DEVIATION REQUEST AND DECISION FORM

Project Name : Rolling Meadows/ Bull Hill Phase-1 (Antelope Ridge at Bull Hill)
 Schedule No.(s) : 5500000324
 Legal Description : A portion of the above schedule number.

A deviation from the standards of or in Section 2.5.2.C.4 of the Engineering Criteria Manual (ECM) is requested.

SHEET TITLE:
DEVIATION EXHIBIT

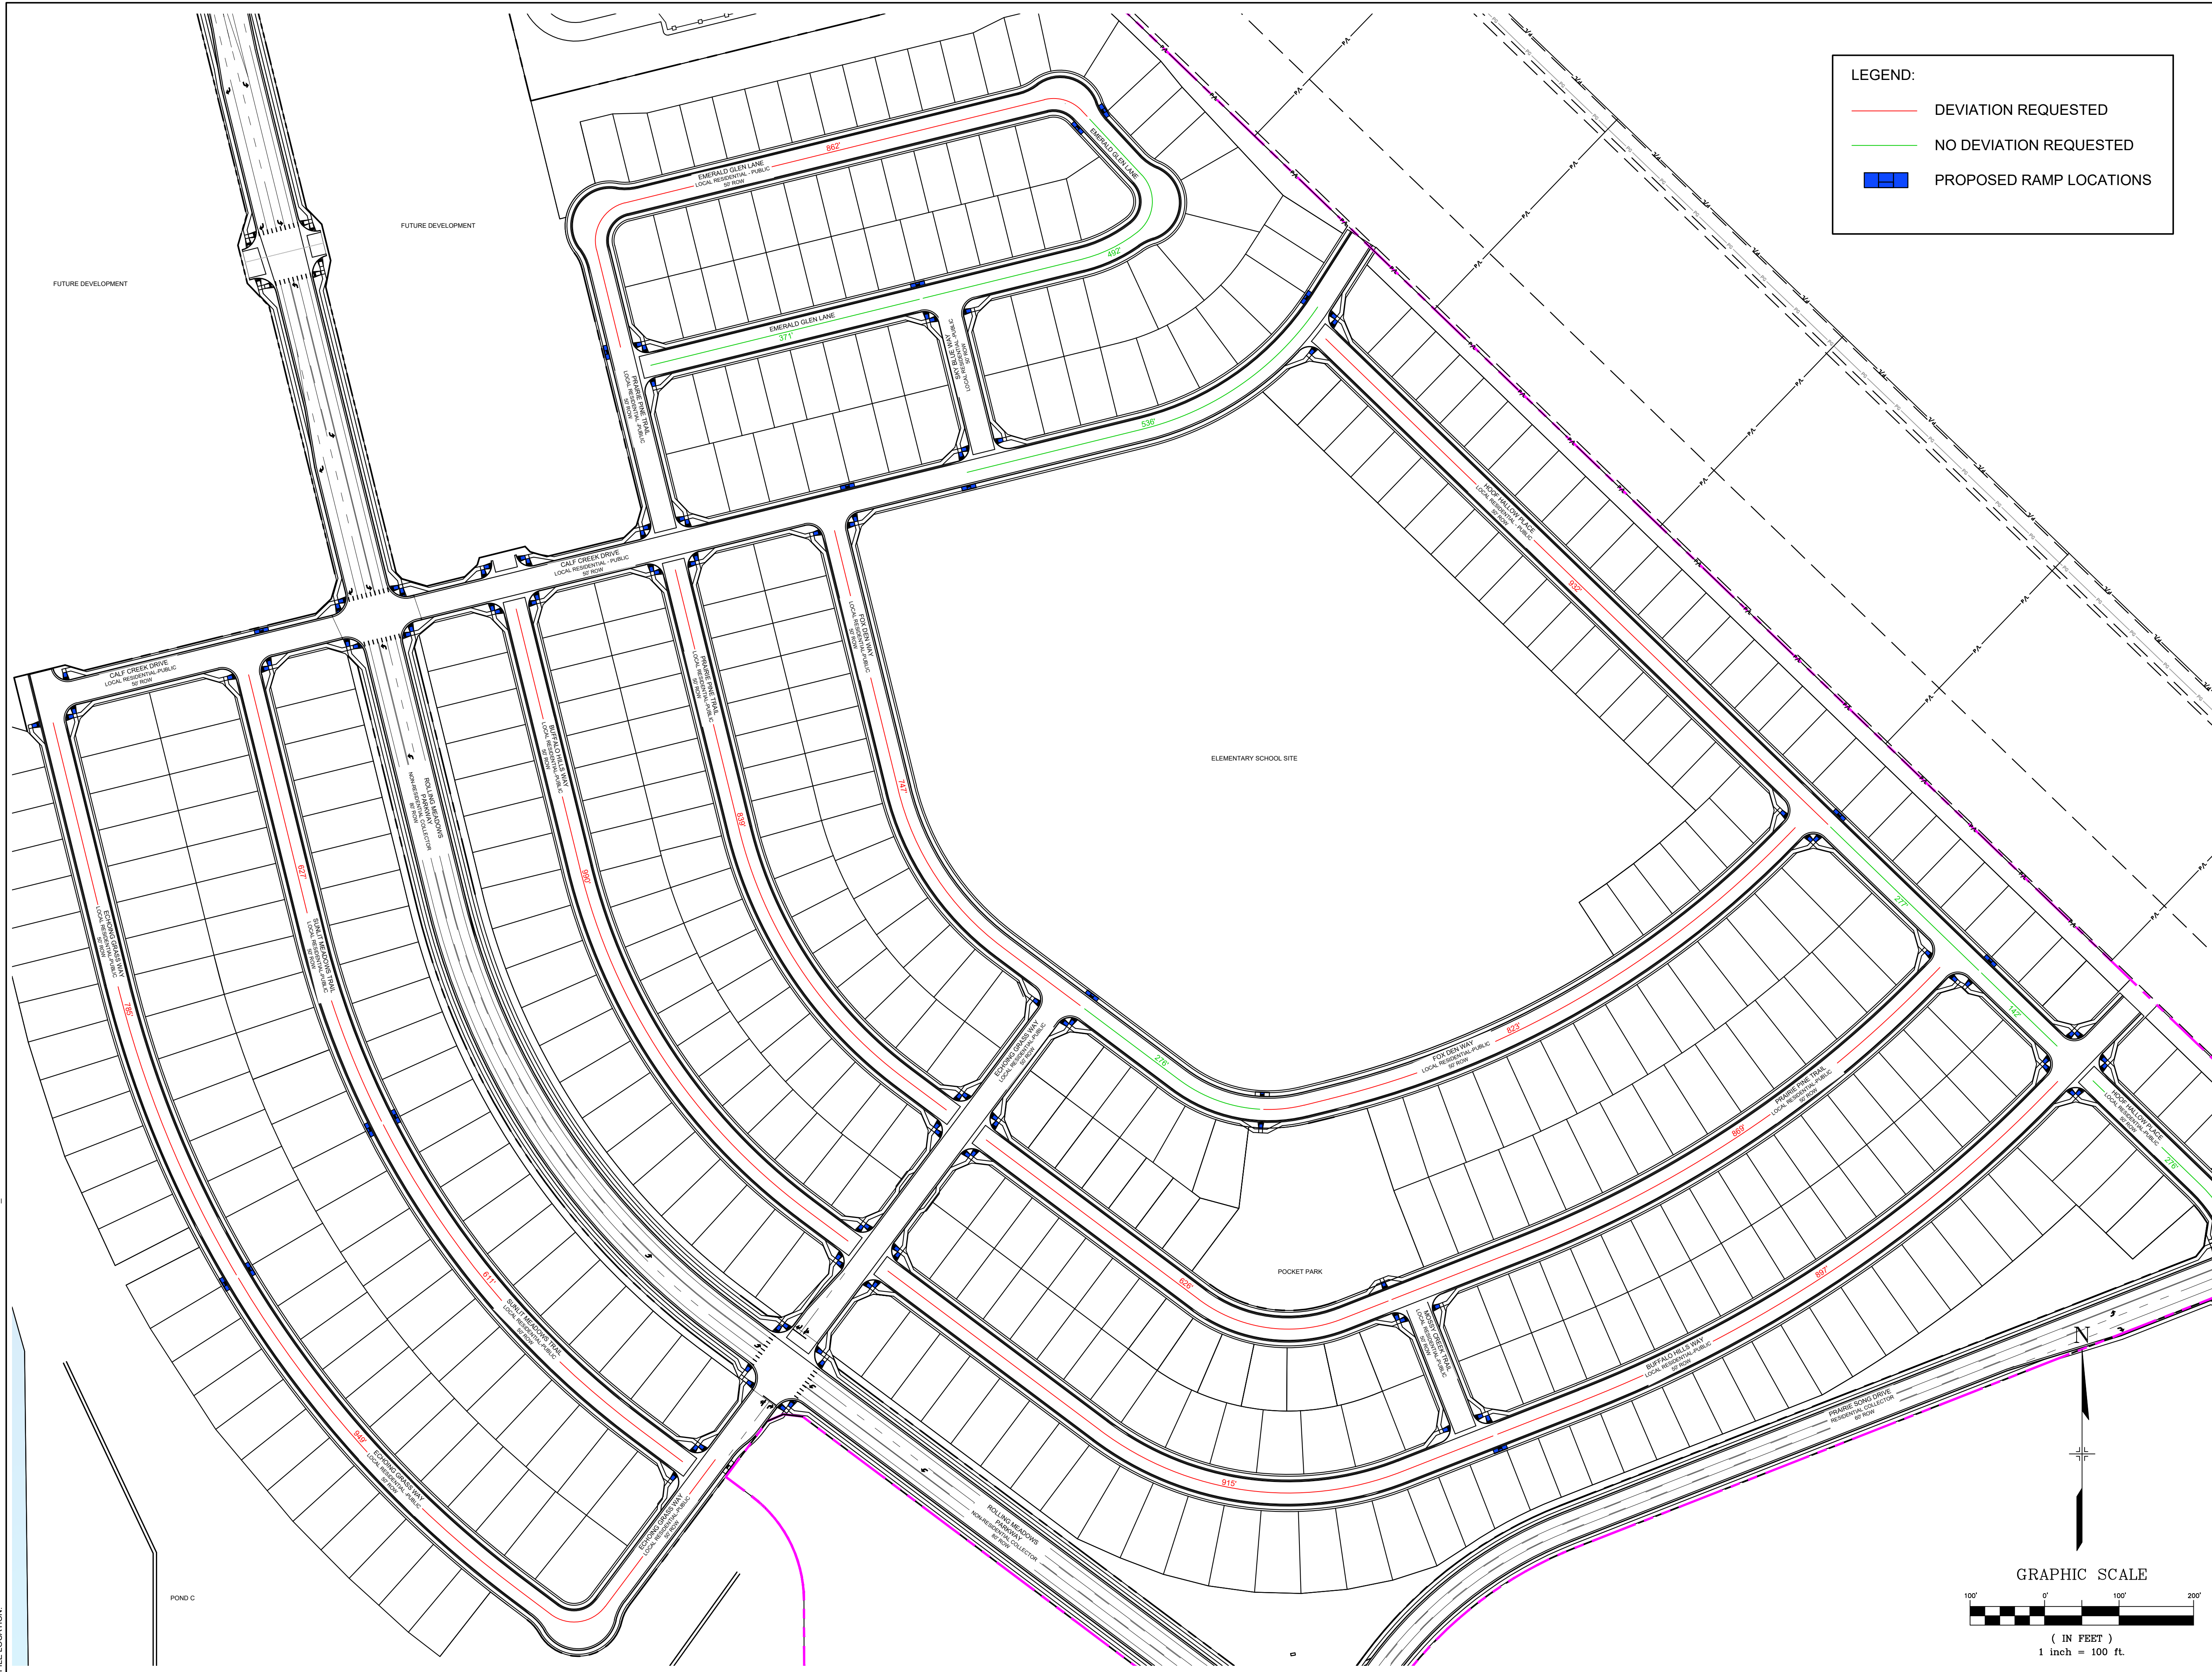
Additional Mid-Block ramps were added on the roadways (Echoing Grass Way & Sunlit Meadow Trail), near the future mailbox kiosk location on Emerald Glen Lane, and between the proposed pocket park and future elementary school on Fox Den Way. Several other locations, that exceed the 600' maximum, a deviation is requested. We feel that Buffalo Hills & Prairie Pine are shorter lengths and although exceeding the 600', that a midblock crossing on the tighter curves is less desirable and less safe for pedestrians with little or no material benefit to the public. Fox Den & Hoof Hallow are adjacent to the future school site and it is our opinion that the school will prefer children to cross at the major, more controlled (crossing guarded) intersections versus children using unprotected mid-block locations.

The proposed alternative to the ECM standard is to not add mid-block crossings at all locations longer than 600 feet. Numerous ramps options are still being provided, however some of these locations will be 600 + feet between ramps. An exhibit has been provided to show the locations provided and not provided including lengths between ramps.

The proposed deviation is requested because we feel the ECM standard in certain particular situations within Antelope Ridge creates a pedestrian safety concern. Mid-Block ramps were added on the longer roadways (Echoing Grass Way & Sunlit Meadow Trail) and near the future mailbox kiosk location on Emerald Glen Lane. Several other locations, that exceed the 600' maximum, a deviation is requested. We feel that Buffalo Hills & Prairie Pine are shorter lengths and although exceeding the 600' a midblock crossing on the tighter curves is less desirable and less safe for pedestrians with little or no material benefit to the public. Additionally, mail box kiosks on these streets will be located at the ends of the streets near proposed crosswalks. Fox Den & Hoof Hallow are adjacent to the future school site and it is our opinion that the school will prefer children to cross at the major, more controlled (crossing guarded) intersections versus children using unprotected mid-block locations.
